Response to reviewers

Anonymous Reviewer n.1

This study investigates the feasibility of soil moisture (sm) detection with cosmic-ray neutron sensors (CRNS) in the center of a squared irrigated field. The authors investigate the sm-neutron relationship and the footprint radius for various scenarios of detector shielding material, field sizes, and combinations of soil moisture conditions in the inner and the outer areas. They conclude that different thickness of HDPE material influences the footprint radius and the detector sensitivity, with HDPE 25mm + Gadolinium leading to the highest sensitivity to soil moisture changes and to the largest footprint radius. Moreover, they found that soil moisture from the outer fields substantially influences the CRNS sensitivity to the irrigated field, especially for small fields.

Figure 1: Response functions with the thermal neutron energy range marked with a red area.

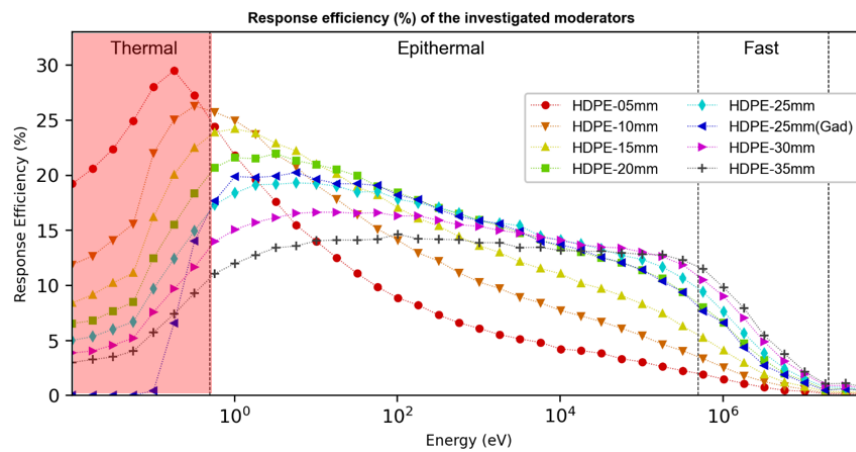
2. The authors conclude that 25 mm HDPE+Gd is the best shielding variant for CRNS detectors (L359) without studying other HDPE thicknesses together with Gd. It is indeed interesting to see gadolinium used for the first time in a sophisticated analysis of detector sensitivity to footprint and soil moisture changes. However, the authors used Gd only in

the 25 mm HDPE setup. In order to distinguish and better understand the effects of HDPE and Gd on the variables of interest, and to find the best performing detector design, it would be necessary to simulate Gd shielding also for different HDPE thickness.

We agree with the reviewer that investigating the effects of a Gadolinium based shielding on different moderator thicknesses would be interesting, at least in general terms. However, to our knowledge, such shielding is currently commercialized only with 25 mm HDPE moderators. Additionally, as shown in the following Figure 1, a Gadolinium based shielding prevents the detection of approximately 90% of thermal neutrons. This effect differs from a HDPE moderator since the sensitivity is not shifted towards higher energies but rather cut in the thermal range. Thus, it can be expected that a 25 mm HDPE moderator with Gadolinium shielding would generally detect less neutrons than a 25 mm HDPE moderator without Gadolinium shielding.

We could then expect that, by adding Gadolinium shielding to a thin moderator that has high sensitivity to thermal neutrons and low sensitivity to epithermal and fast neutrons (e.g., 5 mm HDPE), the number of detected neutrons would decrease considerably (partial removal of the red shaded area in Figure 1). In thicker moderators, the work of Weimar et al. (2020) shows that for moderator thicknesses of 20, 22.5, 25, and 27.5 mm HDPE there are only small differences when the Gadolinium shielding is added. The authors concluded that a 22.5 m HDPE moderator with a Gadolinium thermal shielding provided the best overall performance but with only a marginal difference compared to a 25 mm HDPE moderator (as proposed by Desilets et al. (2010)) with Gadolinium shielding. It is true that thinner moderators yield slightly better signal dynamics at the cost of a small reduction of the count rate. However, such differences are marginal and, in our opinion, not significant when put in the framework on a study such as the one proposed here.

Figure 2: Part-i is a copy of Fig.9 of the manuscript (referred to a 25 mm HDPE moderator with Gadolinium shielding. Part-ii and Part-iii are figures similar to Fig.9 of the manuscript built with data from a 25 mm HDPE and 5 mm HDPE moderators respectively.

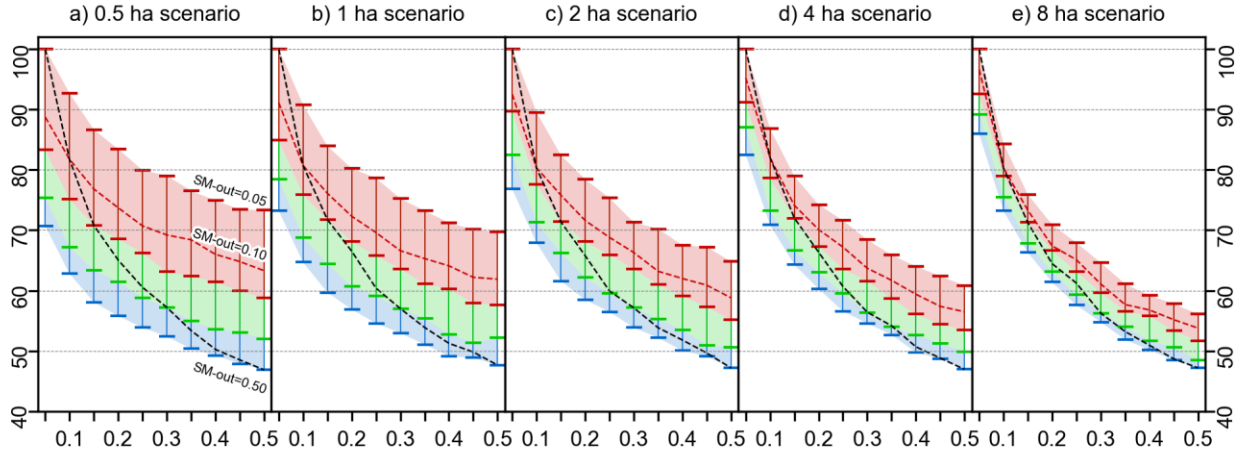
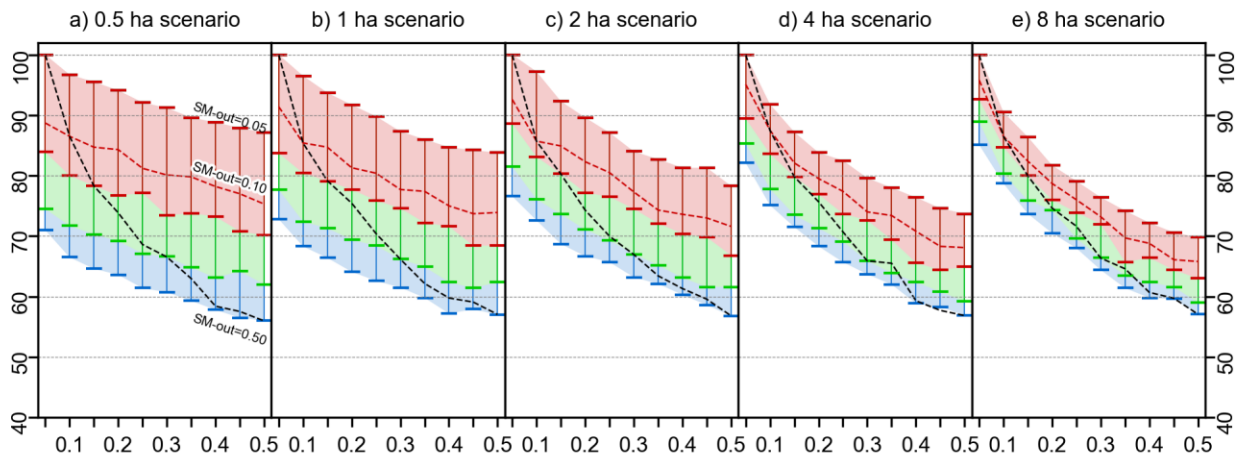
3. The authors conclude that outer sm is an important factor for irrigation monitoring with CRNS by considering only one shielding option that provides the largest footprint. In section 3.4 and 3.5 the impact for inner sm changes on the neutron detector sensitivity is investigated, but only for 25 mm HDPE-Gd (mentioned in 3.4, not mentioned in 3.5). In the same study, the authors find that different shielding options have different footprint radii. So, I would expect that shielding options with lower footprint radii would lead to less impact of the outer sm. Please elaborate on this and whether different shielding options could be recommended for smaller fields than for larger fields to reduce the influence. This might change your conclusion. Also, use this opportunity to join the two otherwise separate parts of "shielding/footprint analysis" and "sm/area analysis", in order to demonstrate that a combination of those two studies in a single paper could actually lead to a greater benefit.

We nonetheless think that the reviewer is raising a fair point and decided to provide additional figures in our reply to the comments. The following Figure 2 was produced starting from Fig.9 of the original manuscript (Part-i). To this, we added similar figures obtained with data from a 25 mm HDPE moderator (Part-ii) and 5 mm HDPE moderator (Part-iii).

As visible in Figure 2, the use of a 25 mm HDPE moderator without Gadolinium shielding, which has an R86 that is 5-10 m smaller than the version with Gadolinium, does not show apparent reductions of the influence of the SM outside the irrigated field. However, there is a general reduction in sensitivity, as can also be seen in Fig. 6 of the manuscript. Furthermore, a 5 mm HDPE moderator, although having a footprint that is sometimes 20 m smaller than that of the 25 mm HDPE with Gadolinium variant, does not show a reduction of the effect of the outside SM. Such effect of the outside SM sometimes appears higher than in the Gadolinium case, but the most important difference is the generally lower sensitivity of the moderator without gadolinium.

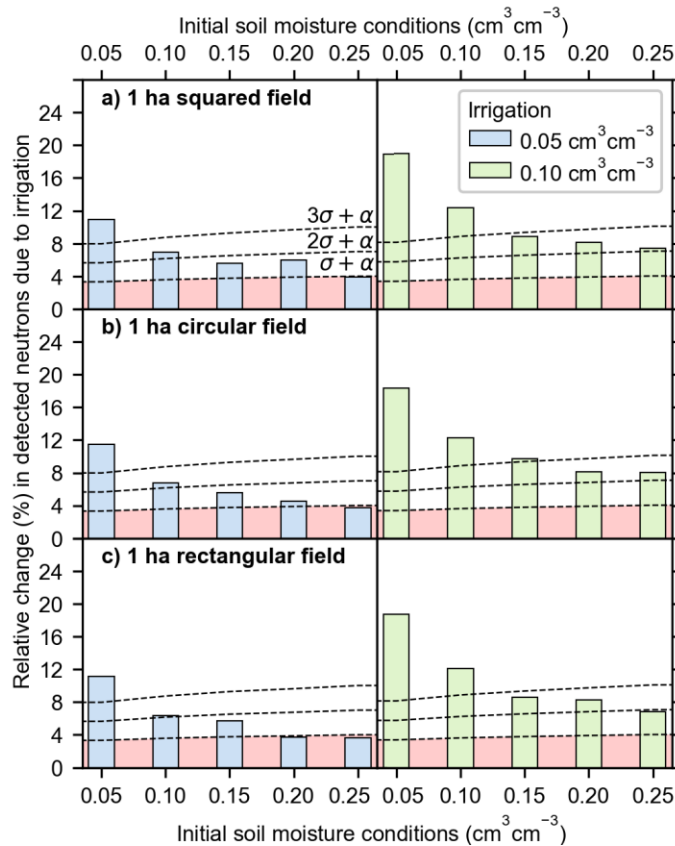
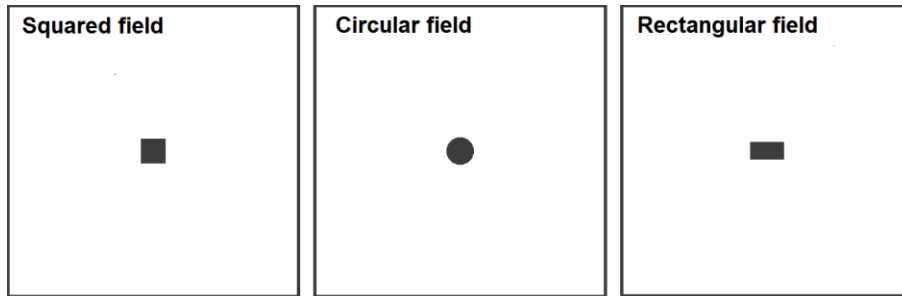
5. The study is limited to one specific case of field geometry: a CRNS detector in the center of a square-shaped irrigated field surrounded by a homogeneous field on all sides. Although simulations of various shielding types and square sizes are scientifically interesting, the transferability of the results to practical field geometries might be very limited. I would recommend to better communicate this limitation, at first by improving Figure 1 with a detector symbol in the center and scales in meters. Second, by providing real-world examples where this scenario could be applicable (I would rather think that radial field geometries would have been a better choice, e.g. for pivot irrigation). Third, by discussing potential deviations and uncertainties of the results if the sensor location would not be ideally centric, or if the field shape is a circle instead of a square. This would allow users to get a better idea whether the results would be still applicable to a certain degree, or whether completely new simulations would be necessary for every single deviation from the presented ideal case.

Furthermore, we tested the simulation of a circular and rectangular (142x70 m) irrigated fields of 1 ha area and compare the results with those of a squared 1 ha irrigated field. The results are shown in Figure 4 in a similar way as they are shown in Fig.8 of the manuscript. In general, differences between the squared, circular, and rectangular shaper are rather small, at least in this simulation setup. Compared to the squared shape, there might be sometimes a small tendency towards higher relative changes in detected neutrons for a circular shape and a tendency towards lower relative changes when a rectangular shape is used. However, results are too similar to draw meaningful conclusions. A clearer picture could possibly be obtained if these two additional scenarios are simulated for the entire soil moisture range of 0.05 to 0.50 cm³ cm⁻³ and for the five investigated areas of the irrigated field. However, this would increase the number of simulations by +200%, which is not feasible due to time and computational constraints and goes beyond the scope of the manuscript. Thus, we decided not to add simulations of different field shapes to the manuscript.

Figure 5: Alternative to Fig03 of the original manuscript using stacked bar plots. Not selected.

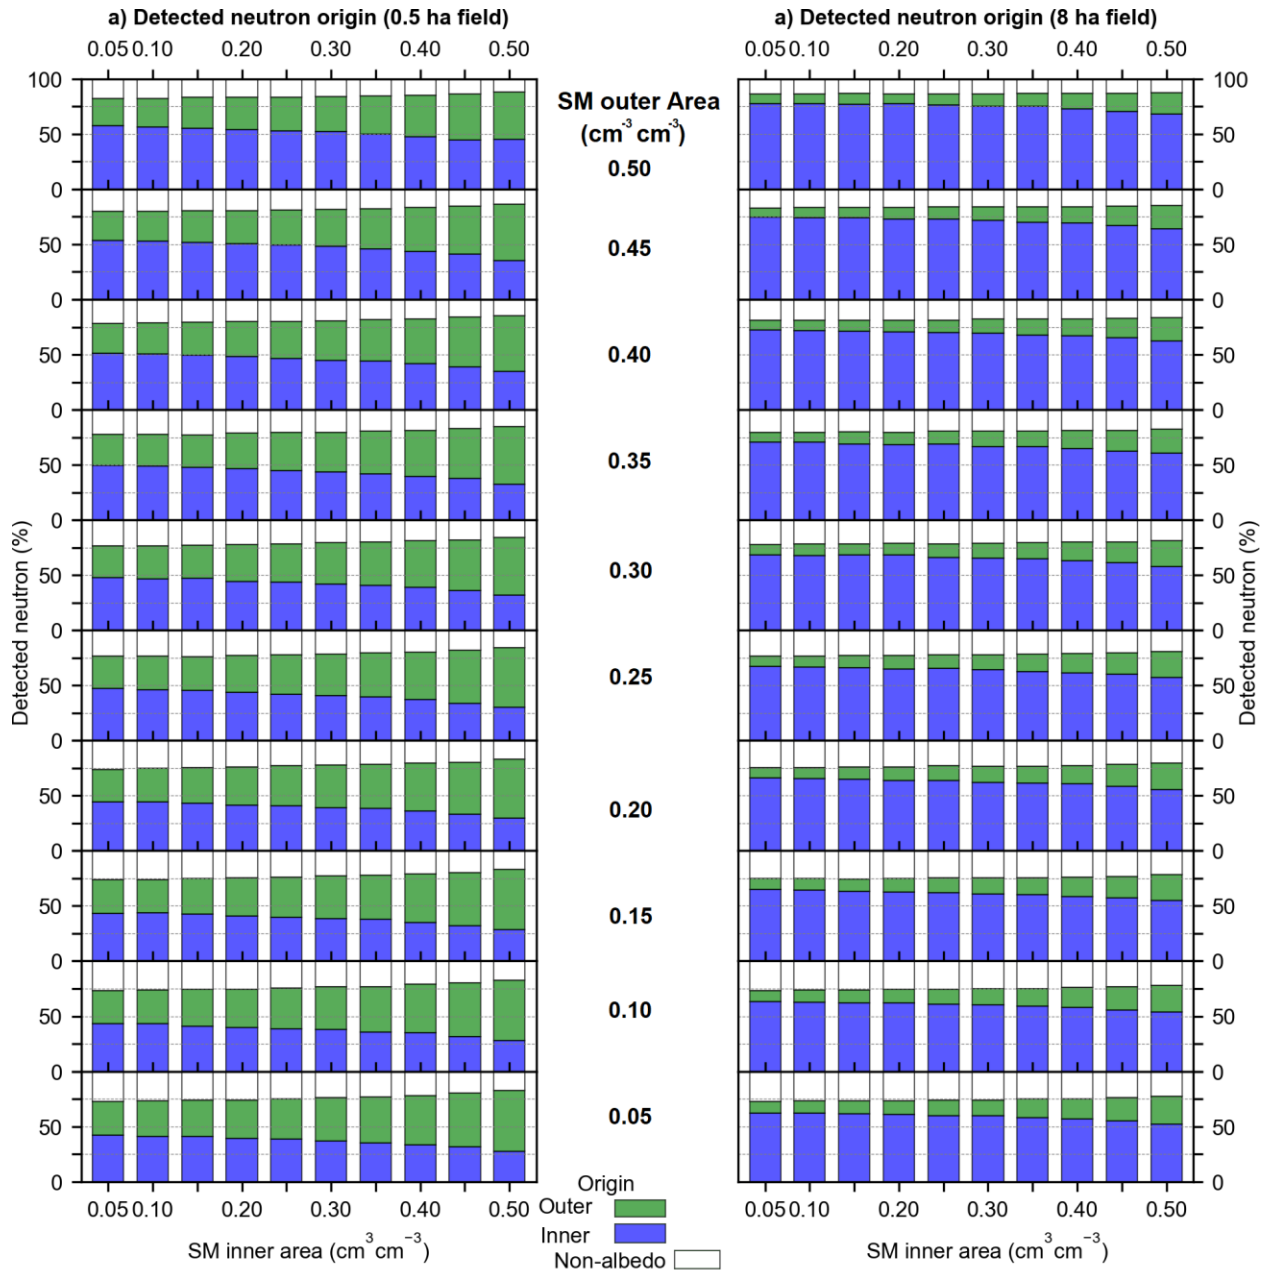
4. Nomograms for the presentation of the results are very hard to read (e.g. Fig 3). I can understand the authors idea to put both, the inner and the outer sm on the two axes, but it took me several minutes starring at the plot to understand what they are showing. And now that I understand it, I still find it hard to read out what fraction of neutrons comes from the inner or the outer part for a given soil moisture condition. Especially since both relative neutrons are not adding up to 100% (due to direct neutrons?). So, I would strongly suggest to reconsider these graphs, focusing on the main message, which probably is: "How do neutrons from inner and outer areas compare?". If two variables need to be compared, try to show them in the same plot. And since they add up to a total neutron count (or to 100% including direct neutrons), the usage of stacked barplots might be good choice. One advantage of a N-over-SM plot would also be that the curves could be easily compared with the conventional N(SM) functions to show how this function changes for different irrigation pattern. Just like in Figure 9. Consider replacing Fig 3 with Fig 9 or at least referring to it.

For the new version of the manuscript, we first attempted to create a figure based on stacked bar plots as this was one of the possible suggestions from the reviewer. The result can be seen in the following Figure 5. Although some details of the figure could be improved, we think that this illustration method does not allow to clearly show many simulation results. Although the difference between the 0.5 and the 8 ha cases is crystal clear (left and right column respectively), the differences in neutron origin between the 100 simulations for a 0.5 ha field is hardly readable. Same goes for the 8 ha simulations.

Figure 7: alternative figure that substitutes Fig.5 in the new version of the manuscript.

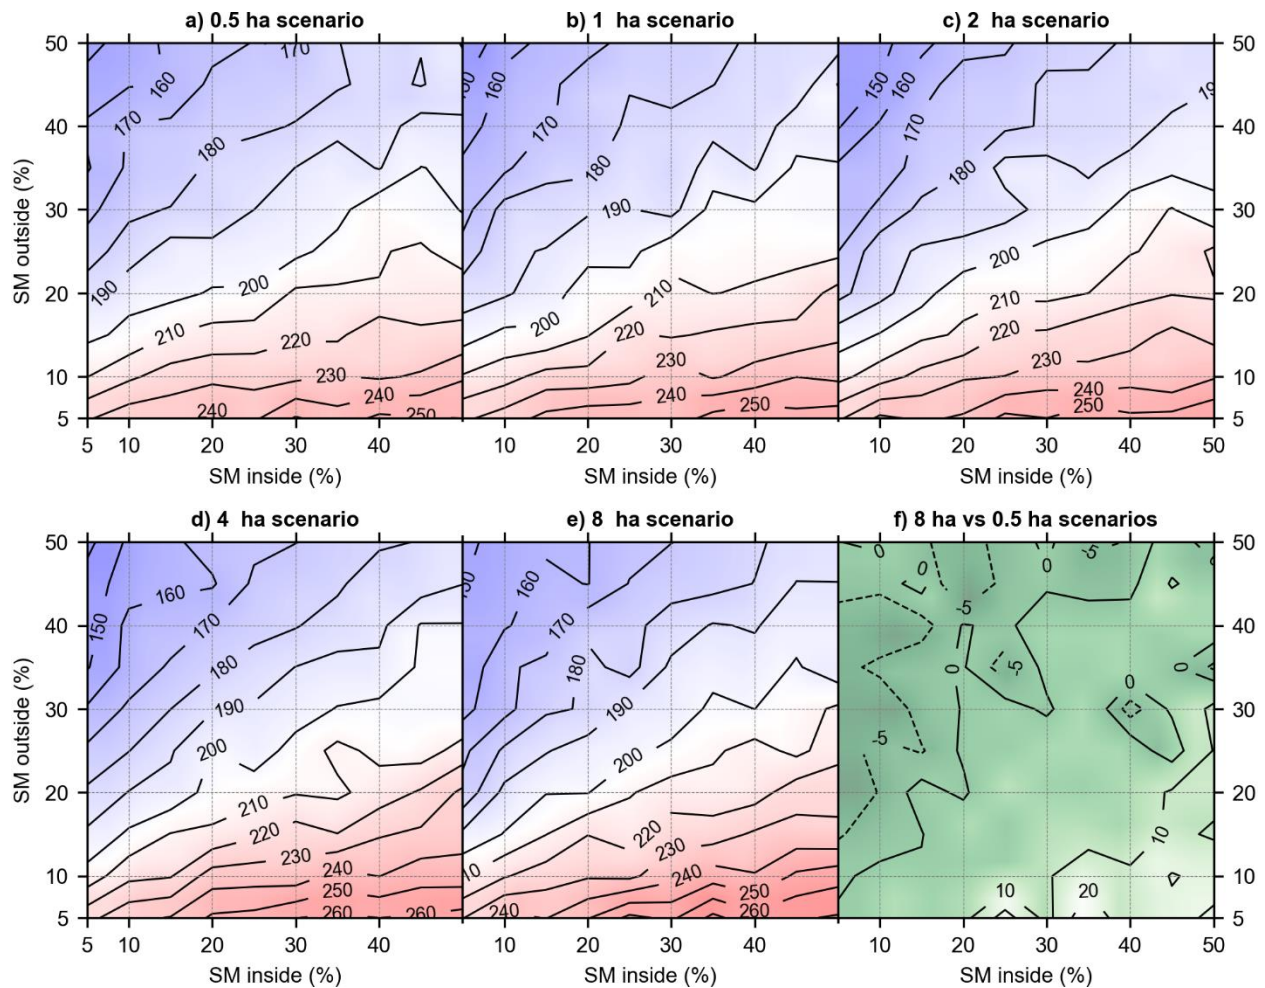
- Figure 5: Since panel f) shows a difference rather than the actual value of R86, the colorscale should be completely different. However, it still has blue and yellow colors just like the colormap from the other panels. Please make f) more distinguishable, by choosing a more distinguishable colormap (e.g., red-white-black). Moreover, using terrain colormaps for R86 is not a good choice. Blue stands for water, but low radii have nothing to do with water. Try to use a more linear colormap (e.g., greyscales), or none.

We carefully considered the comment of the reviewer and critically examined Fig.5 of the original manuscript version. We agree that a simpler and clearer version could be produced. As low R86 can be somehow associated with wet soil conditions and large R86 with dry soil conditions, we decided to use a simpler blue-red scale for the panels a-e. Thus, green (intensity) was a good contrasting choice for panel f. We tested the use of greyscales, but it made the black contours less readable. Also, the use of no colormap resulted in a figure that was like the original version of Fig.3, which we now understand had poor readability. Thus, we believe that this new Figure 7 is a good and readable compromise, and we will use it in the new version of the manuscript.

Figure 8: alternative figure that substitutes Fig.6 in the new version of the manuscript.

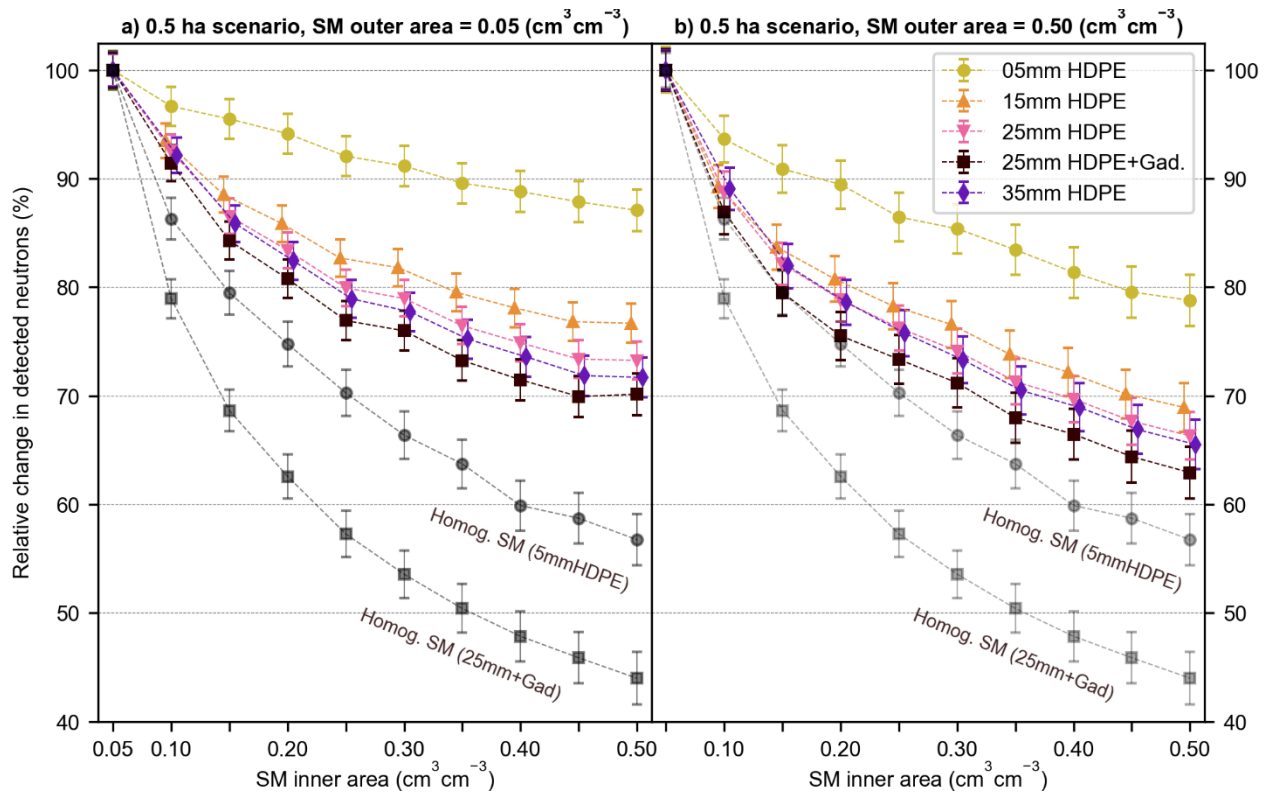
- Figure 6: Can you add conventional $N(sm)$ functions for the purely homogenous case for comparison?

Following the reviewer suggestion, we will include relative change in detected neutrons for homogeneous SM variations (i.e., homogeneous area or irrigated field of infinite dimension). The result is shown in the following Figure 8. As this new Fig.6 is more informative than the previous version, it will be added to the new version of the manuscript. The caption will be modified accordingly.

Figure 9: alternative figure that substitutes Fig.8 in the new version of the manuscript.

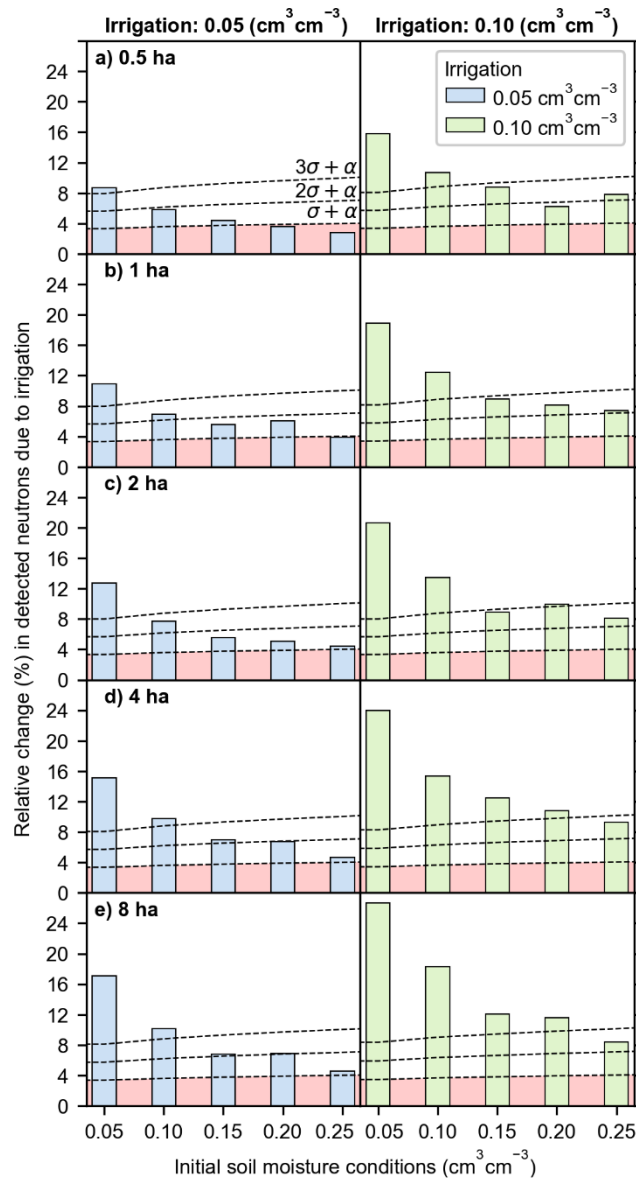
- Figure 8: Why are some bars larger for higher sm than others at lower sm? Is this an effect of the simulation uncertainty? Can you provide an errorbar for the bars?

The results of this study are subject to statistical uncertainties. When looking at small differences, results are often influenced by fluctuations, which we for example see in Fig.8. In order to quantitatively understand and classify our findings, we provide a measure of certainty by comparing them to the standard deviation of the respective data set. In our opinion, the dashed lines show the error bars of the bars in a clearer and simpler manner. We thank the reviewer here as we also noticed that the red area below $\sigma + \alpha$ mentioned in the caption of Fig.8 was not visible. We also now use multiple simulation results for the initial homogeneous soil moisture conditions. We will thus provide a new version (Figure 9) of the figure where such area is clearly marked, which will also help the reader in this context. We also will modify part of the caption to have a clearer description: "The bars show the relative change in detected neutrons induced by the irrigation event while the dashed lines show the prescribed detection certainty thresholds.". Please note that further modifications to Fig.8 were made according to the comments of reviewer n.2.
